ENGINEERING CHANGE NOTICE

Proj. ECN W-105-172

2. ECN Category (mark one)	3. Originator's Name, Organization, MSIN, and Telephone No.		4. Date
Supplemental ☒	K.L. EWER, KEH, E6-04, 6-1294		3-19-92
Direct Revision ☐	5. Project Title/No./Work Order No. W-105/ 242-A EVAP RETTN BASINS	6. Bldg./Sys./Fac. No. 242-AL	7. Impact Level / SC 3EQ / 3
Change ECN ☐			
Temporary ☐			
Supersedure ☐	8. Document Number Affected (include rev. and sheet no.) SEE BLOCK 12	9. Related ECN No(s). SEE BLOCK 12	10. Related PO No. N/A
Discovery ☐			
Cancel/Void ☐

13a. Justification (mark one)	13b. Justification Details
Criteria Change ☒	ITEMS 9, 12-17; LOI 93 - DIRECTS KEH TO PROVIDE LEAK DETECTION INSTRUMENTATION AT CATCH BASINS WITH LOCAL ANNUNCIATION & ALARM AT 242-A EVAP.
Design Improvement ☐	
Environmental ☐	
As-Found ☐	ITEMS 1-8, 10-19; LOI 95 - PROVIDE CONTINUOUS LIQUID LEVEL INSTRUMENTATION FOR BASINS (6" NORTH SAMPLE PORT RISER) AND LEACHATE SUMPS (4" LEACHATE RISER) WITH LOCAL READ-OUT & 242-A ALARMS
Facilitate Const. ☐	
Const. Error/Omission ☐	
Design Error/Omission ☐

TYP - CONTINUOUS LEACHATE LEVEL INTERCONNECTION DIAGRAM

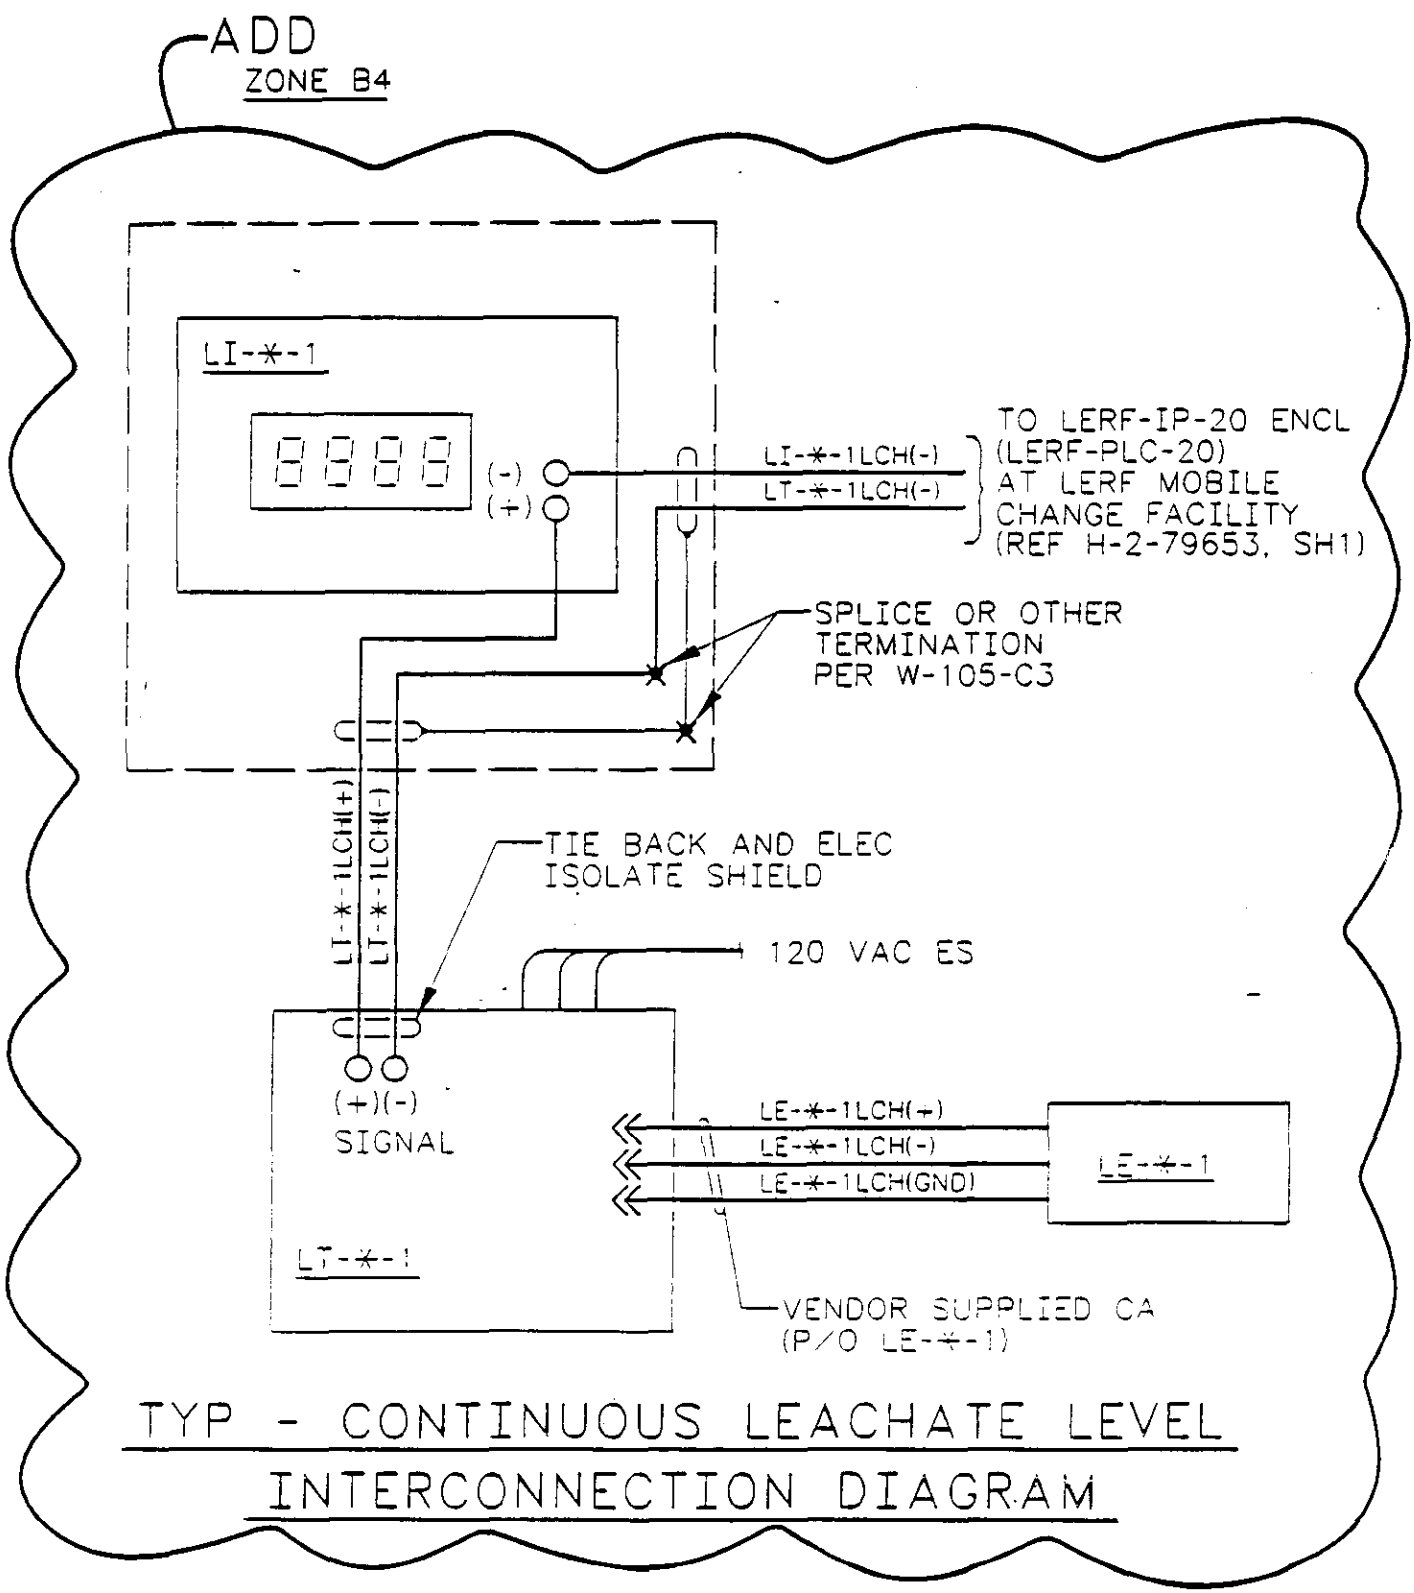
14. REVISE TITLE BLOCK & DETAIL 3 PER PAGE 14.
15. REVISE LEACHATE LEVEL INTERCONNECTION DIAGRAM PER PAGE 15.

KAISER ENGINEERS HANFORD	ENGINEERING CHANGE NOTICE SKETCH					
Ref. Dwg.	Sh.	Rev.	Prepared By	Checked By	ECN No.	Page
H-2-79654	1	0	K.L.EWER	4-8-92	W-105-172	16

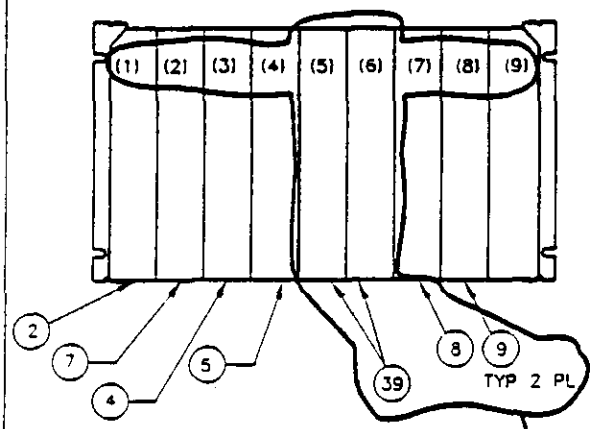
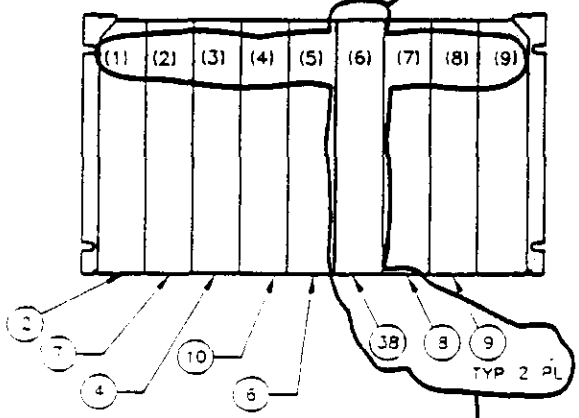
18. REVISE TITLE BLOCK, GENERAL NOTES, MATL LIST & PLC DETAIL PER PAGE 16.

REVISE

ADD

ADD & REVISE AS SHOWN

LERF-IP-20 AND EVAP-IP-10 ENCLOSURE MOUNTING DETAIL 2

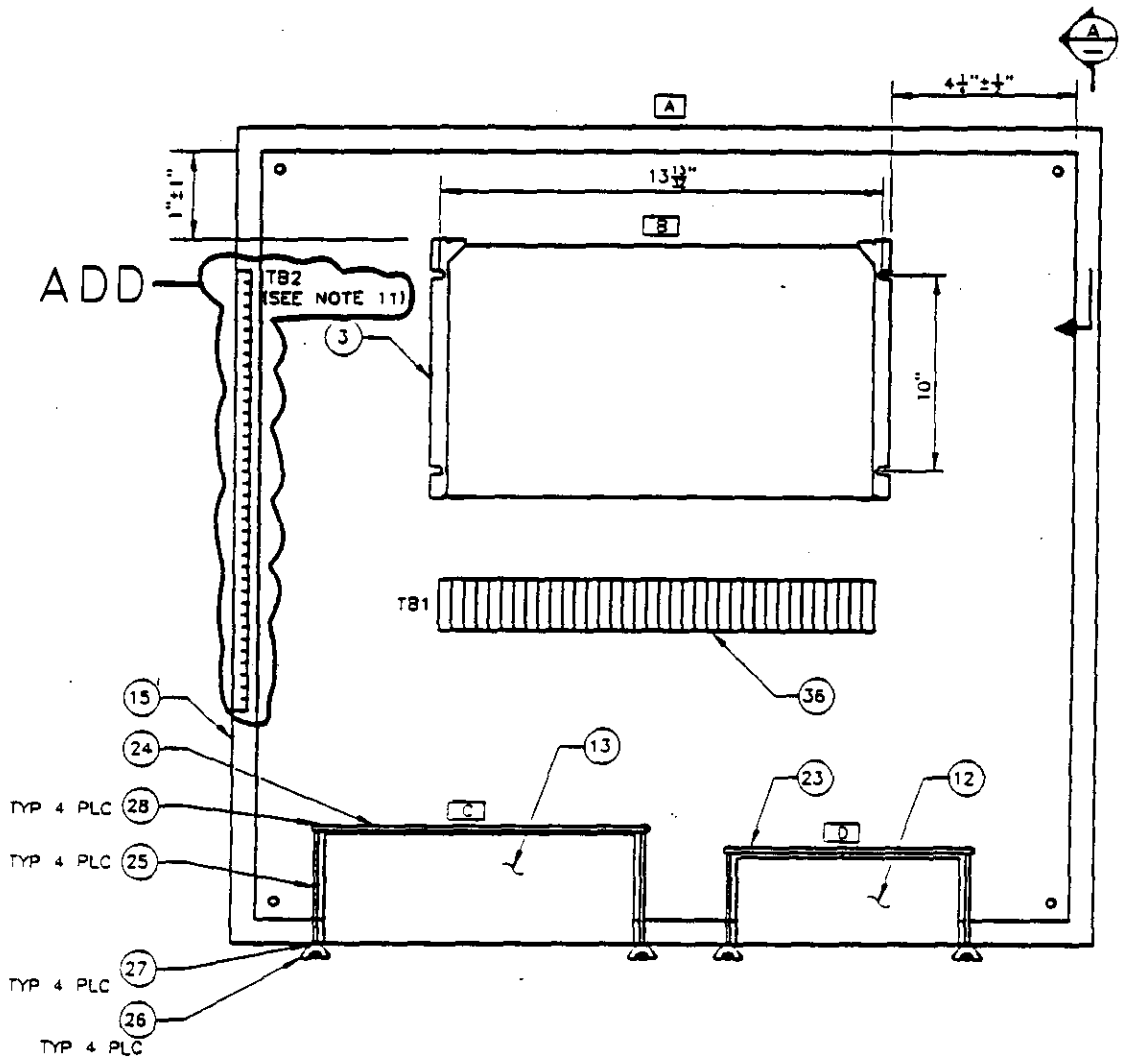
19. REVISE TITLE BLOCK & DETAIL 2 PER PAGE 17.

MODIFY

Ref. Dwg.	Sh.	Rev.	Prepared By	Checked By	ECN No.	Page
H-2-79592	2	0	K.L.EWER	4/8/92	W-105-172	19/22

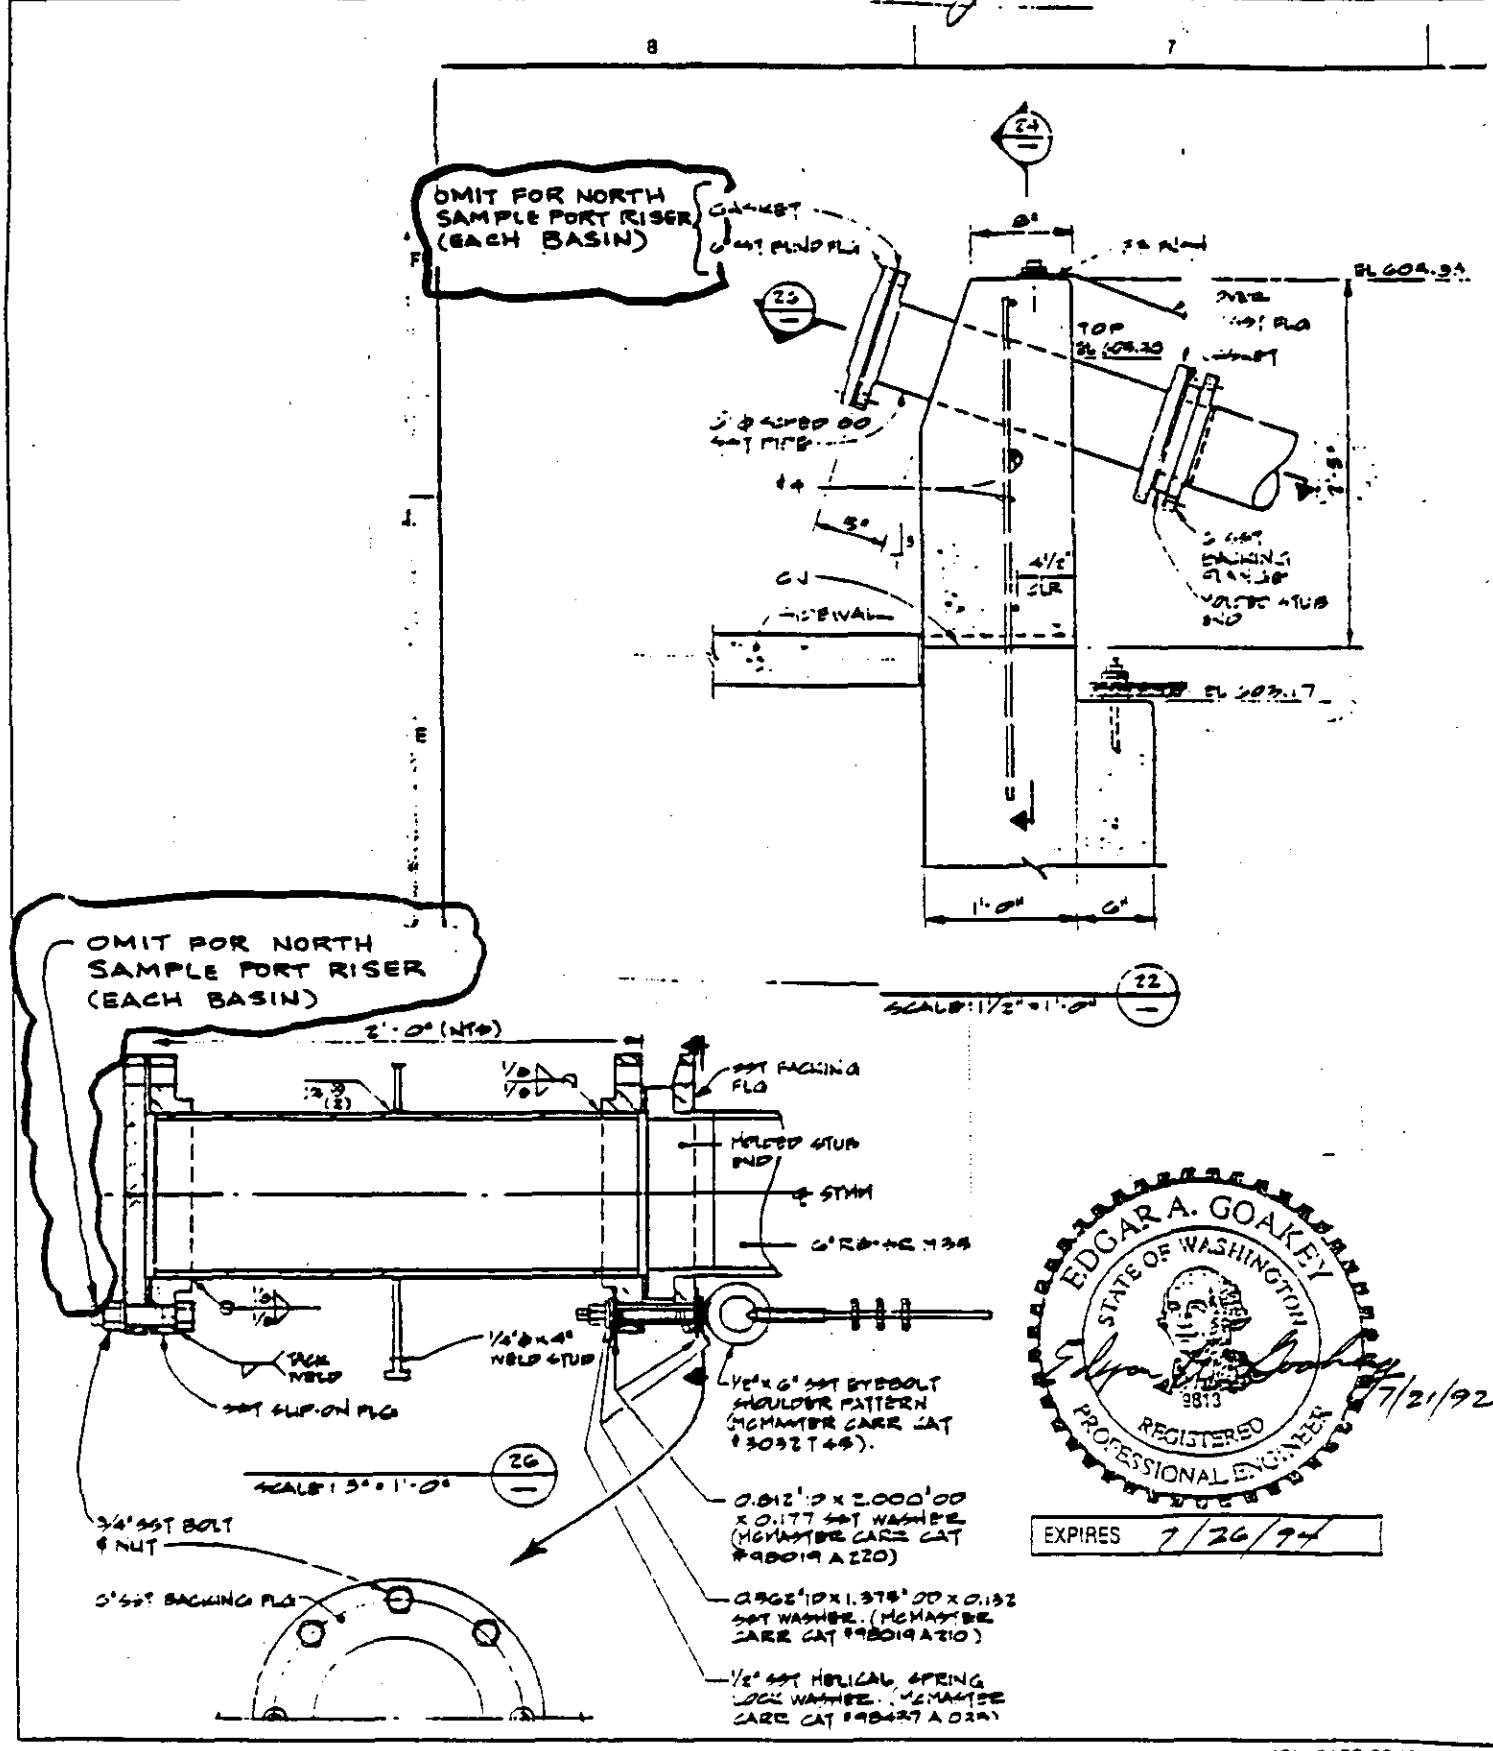
21. REVISE DETAILS 22 & 26 PER PAGE 19.

242-AL MOBILE CHANGE FACILITY WIRING DIAGRAM

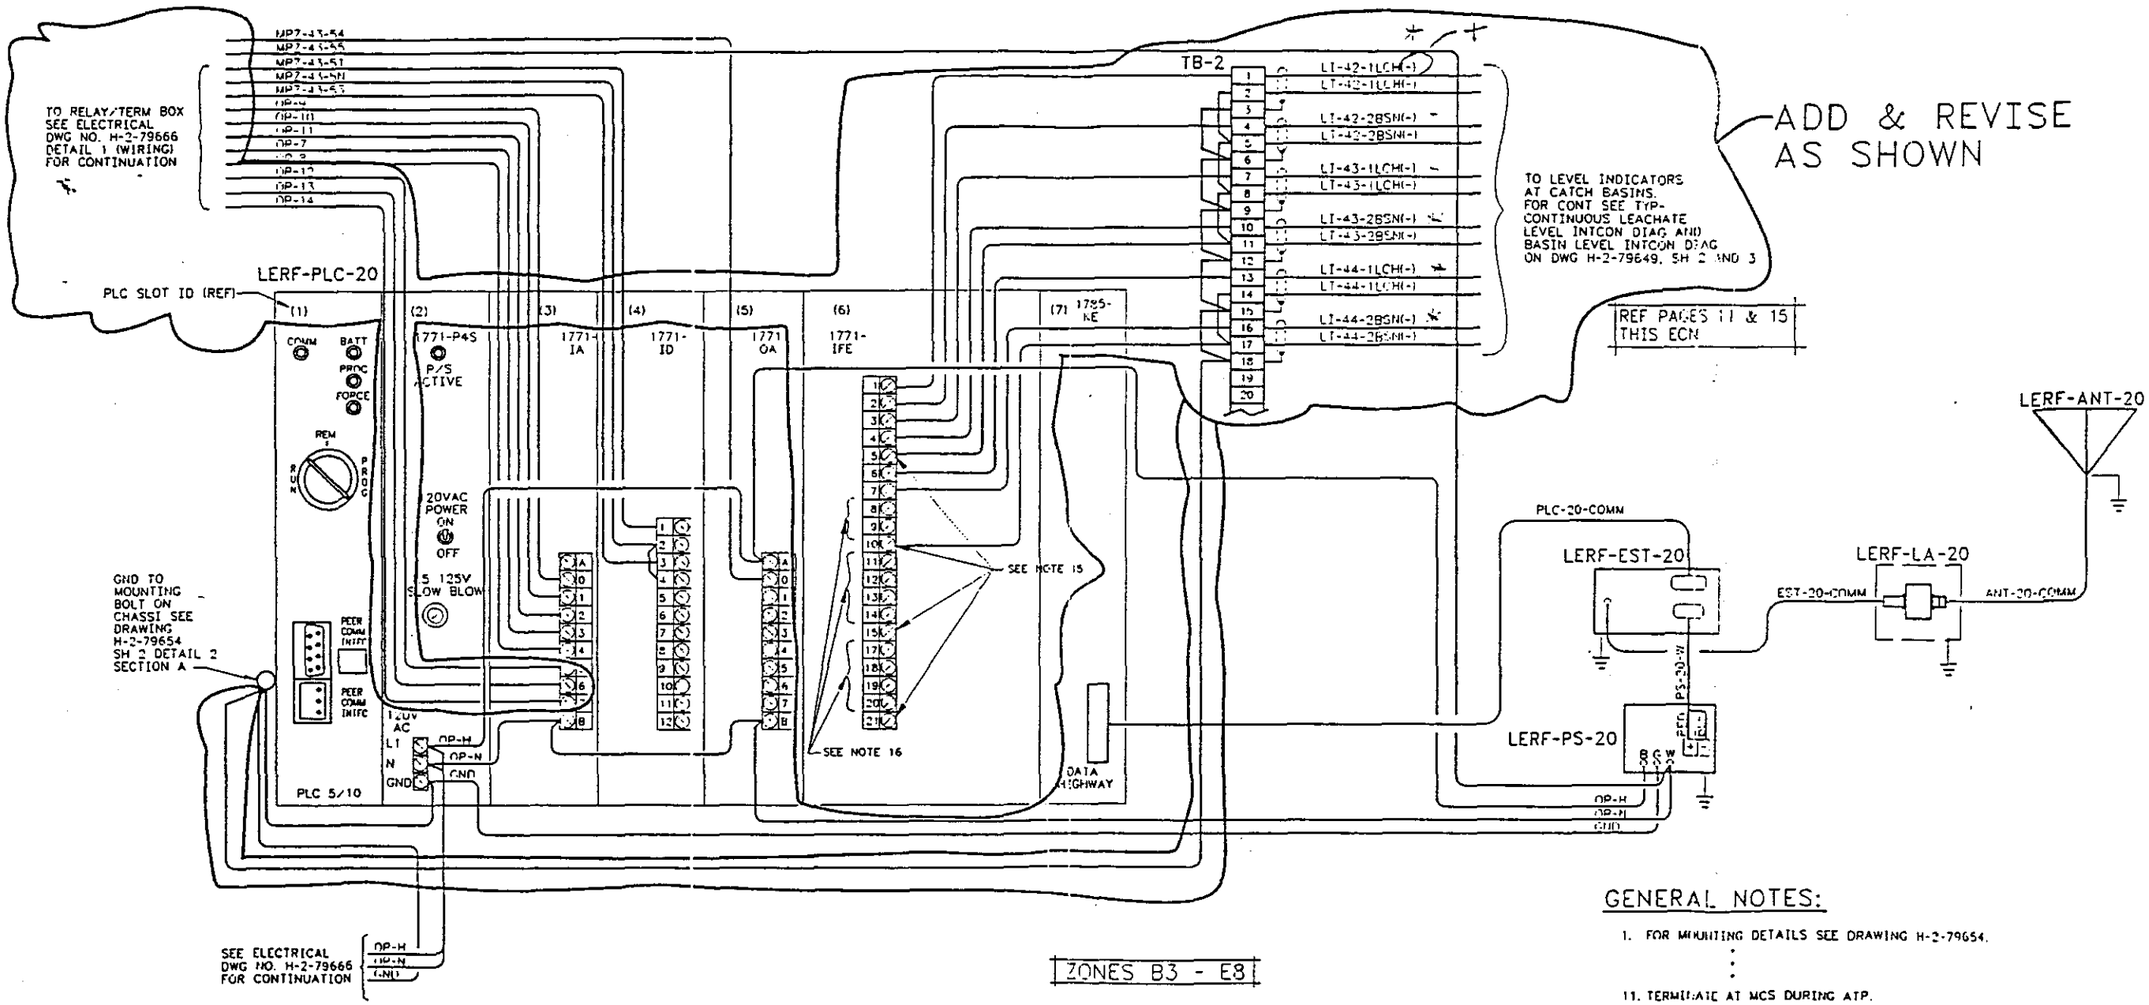
16. REVISE WIRING DIAGRAM & GENERAL NOTES PER PAGE 20.

ADD & REVISE
